**TO:** James L. App, City Manager  
**FROM:** Ronald Whisenand, Community Development Director  
**SUBJECT:** Modification of Standard Street Improvements – Kleck Road, Tract 2805  
**DATE:** March 6, 2007

## HIDDEN OAKS TENTATIVE MAP TRACT 2805

Subject: Tract 2805, Hidden Oaks

## MODIFIED CITY STD A-9 STATION 2+20 - 3+40

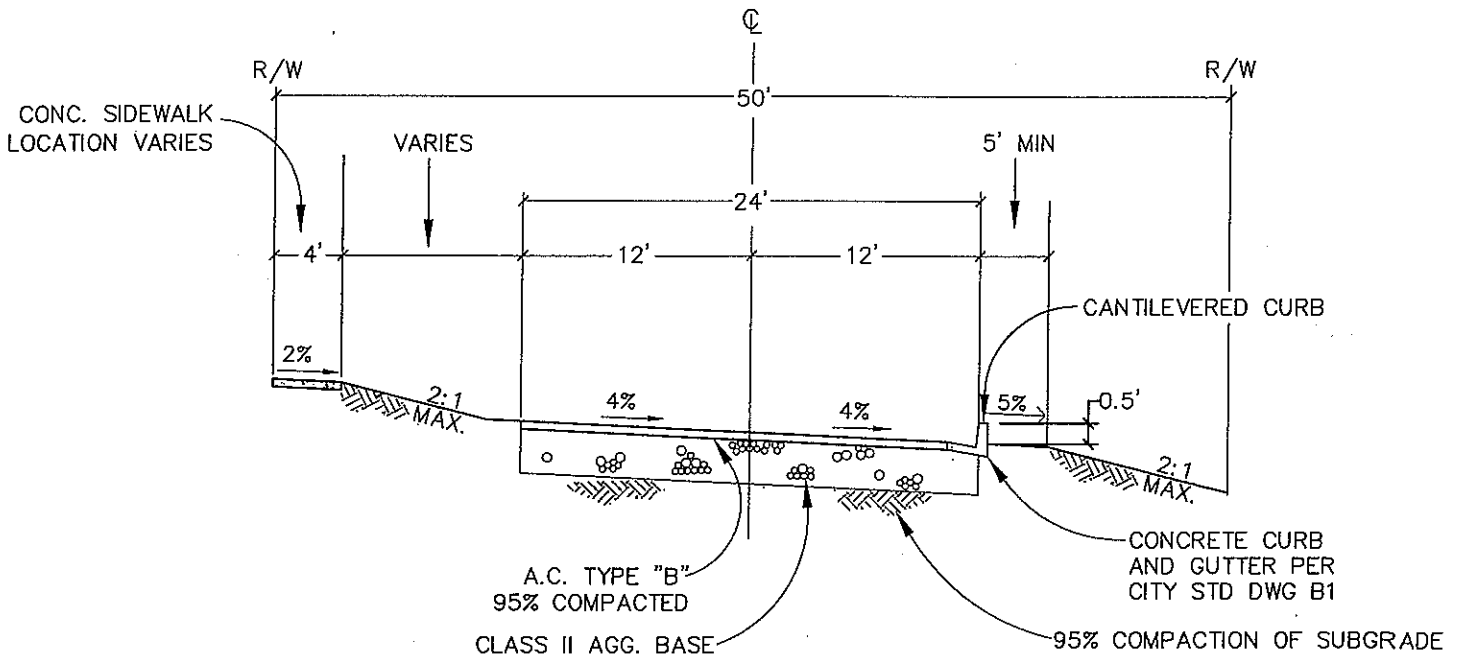
3. In a letter dated February 22, 2007, North Coast Engineering representing the subdivider, Brian O’Kelly, request that the curb on the north side of Kleck Road be eliminated in order to reduce grading and to minimize impacts on oak trees.

The subject project was originally reviewed and approved by the Planning Commission on July 11, 2006. In accordance with condition number 17 of Resolution No. 06-0058, we would like to request the review and approval of the proposed modification to the City Hillside Street Standard A-9 for Kleck Road. The extension of Kleck Road into Tract 2805 will serve 13 new homes. The new subdivision is in a hillside area with numerous oak trees. The proposed modification to the hillside section removes the concrete curb and gutter from one side of the street (the north side). The street will be superelevated, uniformly sloping from north to south, and run-off will be conveyed on the south side of the street in the standard concrete gutter. The resulting cross section reduces the impact to the adjacent oak trees and decreases the grading necessary for the road.

Please review the attached proposed modified A-9 cross section for Kleck Road for presentation and request of approval to the City Council.

**Conclusion:** The proposed modification to eliminate curbs on the north side of Kleck Road in Tract 2805 has been reviewed by the City Engineer. Typically, curbs on both of sides of streets control drainage. The elimination of a raised curb on the north side of this section of Kleck Road will result with some silt and debris washing from the higher to the lower side of the street. However, Tract 2805 is specifically designed with minimal grading to mitigate impacts to oak trees to the greatest extent possible. Raised curb and gutters on both sides of the street require a level cross-section. The elimination of a raised curb creates the opportunity for a sloped cross-section which adheres more closely to the existing terrain. This design would appear appropriate for this portion of Kleck Road. The appropriate treatment is a curb, flush with ground surface, installed on the north side of Kleck Road for long term stabilization of the paving.

SECTION 1. That the City Council of the City of El Paso de Robles does hereby approve of the modification of Street Standard A-9 in Tract 2805 to install curbs, flush with pavement, on the north side of Kleck Road in order to minimize grading and impacts on oak trees.
